LIGO- T0900629-v1

**ADVANCED LIGO**

Response to questions from the review panel on the  
Final Design Review of the ETM/ITM ears

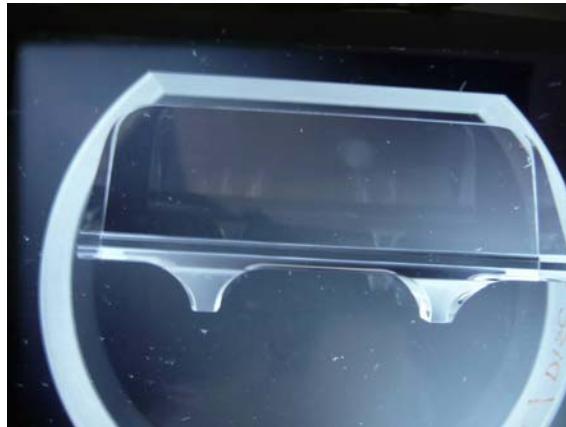
**Q** The allowable fiber and bulk stresses appear different, please explain.

**A** The strength of silica is highly dependent on the number and size of flaws in the surface and bulk of the material. Fibres are pulled at a very high temperature and are never touched by human hands. They are therefore pristine and have very few flaws, which makes their average strength very high (in the order of 4 GPa). The ears are bulk fused silica and we therefore use the manufacturers quoted bulk average strength. In addition work is done to seal cracks in the surface with the flame polishing step and so to increase the strength of the ear. We take the conservative approach of using the average bulk strength stated by manufacturers for the ears.

No stresses in bonded ear that has not been welded

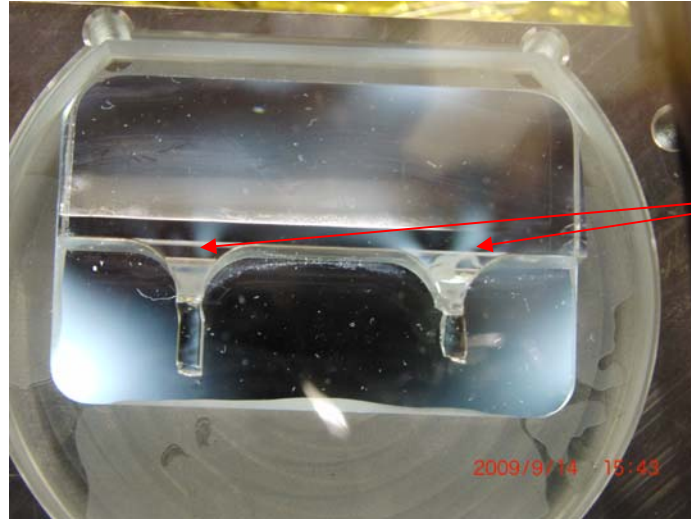
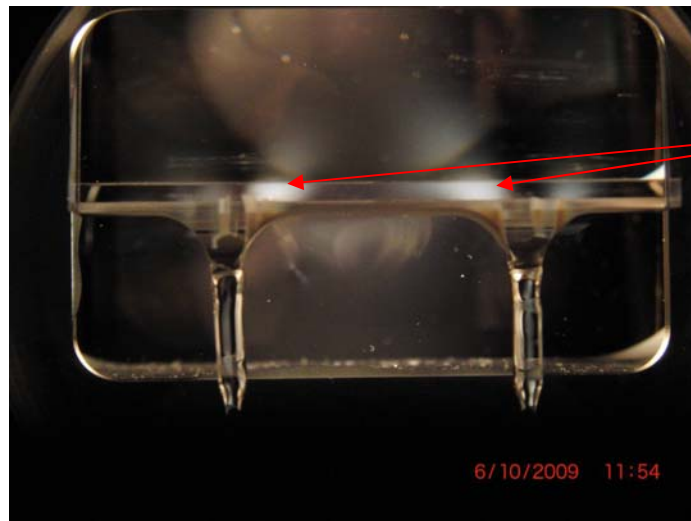
**Q** Is there, or has there ever been, a check on residual stress in the ears after bonding?

**A** Yes, residual stress after bonding and stresses in the ears after welding have been checked using crossed polarisers. No stresses have been observed in unloaded bonded ears.

Some stresses have been observed after welding, with no load. And some additional stresses have been observed when the fibres are under load. In those cases a white hue-type glow is seen. It is difficult to quantify the stresses, however the stresses seen have low intensity glows. Much higher intensity glows have been observed in samples that have been exposed to thermal loading (heating with hydrogen oxygen flame).

Typical thermal stress ranges after welding and welds not loaded

Stress in ear after laser welding, no load

Typically stresses become slightly more pronounced when under tension

Stress in ear under full tension
